**Re: Permit No. M-1980-244; Cripple Creek & Victor Gold Mining Company; Cresson Project;
Technical Revision 147 – Adequacy Review No. 1 Response**

On March 10, 2025, the Cripple Creek and Victor Gold Mining Company (CC&V) received the Division of Reclamation, Mining and Safety (DRMS) Adequacy Review No. 1 of Technical Revision (TR) 147 to permit M-1980-244, regarding the ECOSA Pumpback System. Below are DRMS comments in **bold** and CC&V's response in *Italics*.

Figure 1. ECOSA/Grassy Valley Monitoring Well Location Map

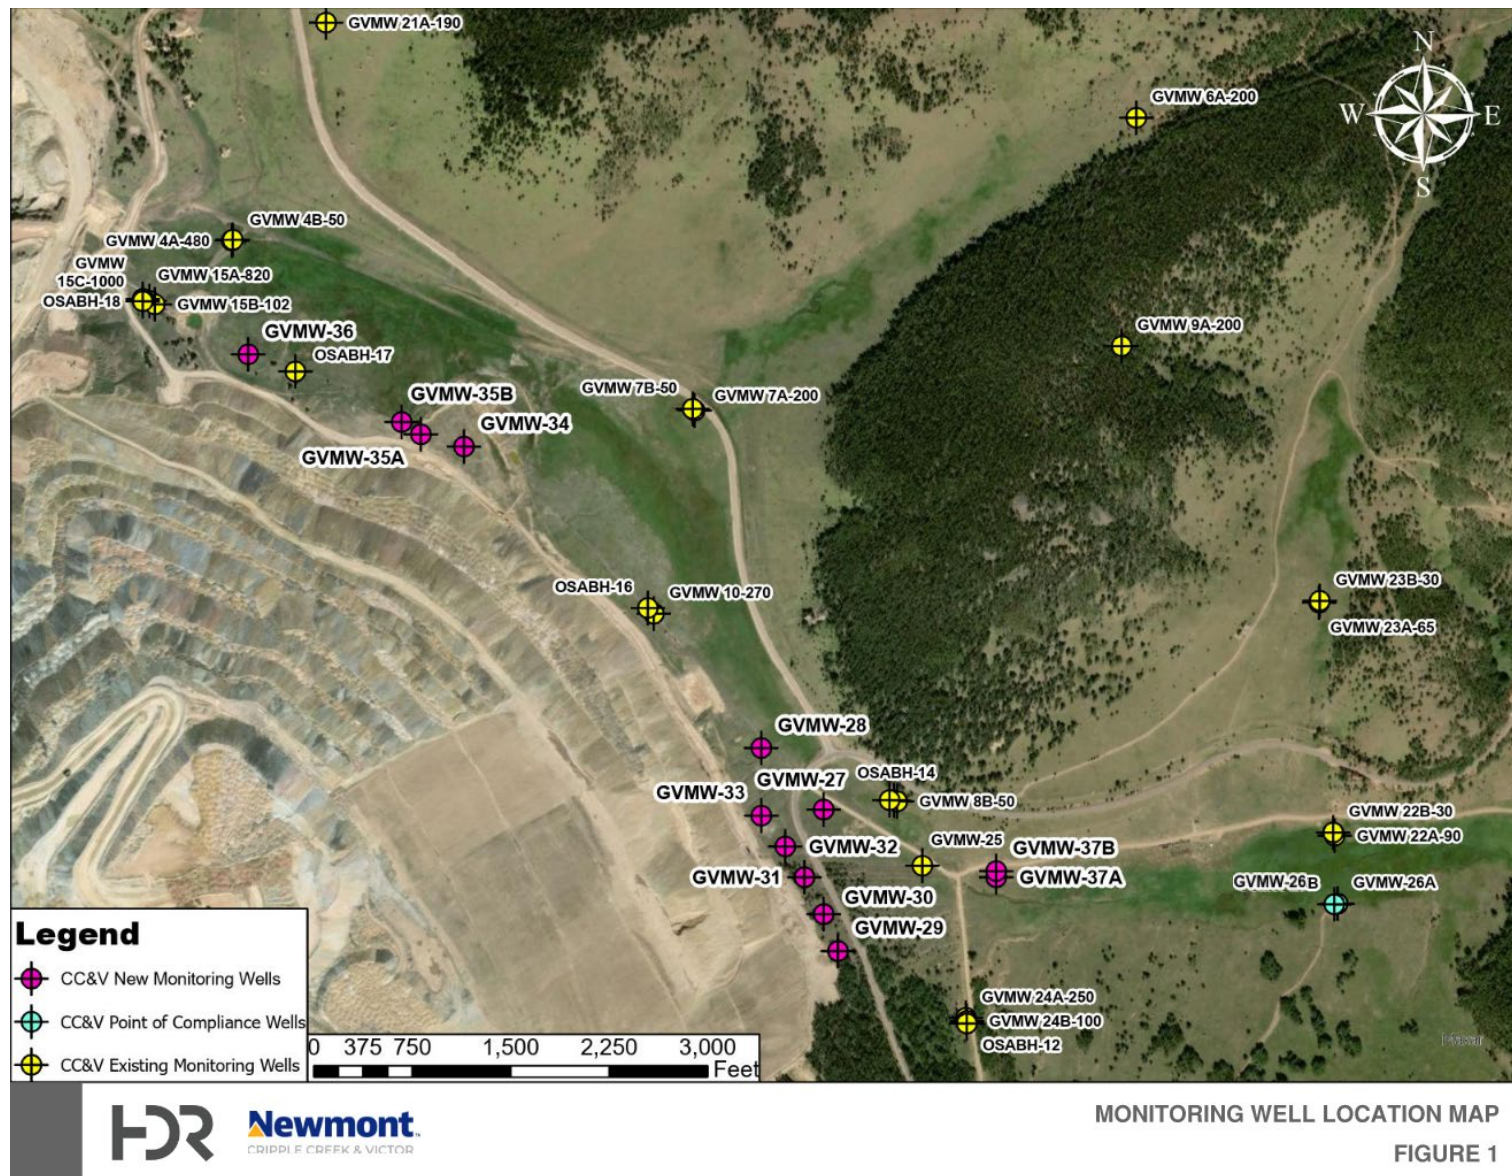
1. **Figure 1 of the Aquifer Testing Report incorrectly identifies GVMW-27B as a Point of Compliance. Please update the figure to accurately reflect the Points of Compliance.**

Figure 1 within the Aquifer Testing Report has been revised and is included within Attachment 1.
